#2044

**Subject: Potential Electrical Shock Hazard Associated With The Power Wave AC/DC 1000**

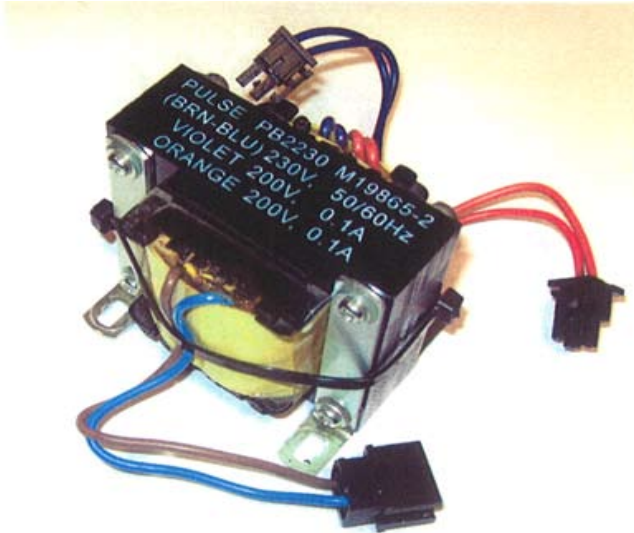
The style auxiliary transformer that can fail can be identified by the designators: PULSE, PB2230. The photograph below depicts the auxiliary transformer that needs to be upgraded.

If you have a Power Wave AC/DC 1000 with a serial number covered by this notice, please contact your local Lincoln Electric Authorized Service Shop or Lincoln Electric Customer Service at [don\\_buchanan@lincolnelectric.com](mailto:don_buchanan@lincolnelectric.com) or 877-837-8145 to arrange for the transformer to be replaced at no cost to you. The transformer service kit 9SS27540 will be obtained and installed by Lincoln Electric's Authorized Service Shop Network.
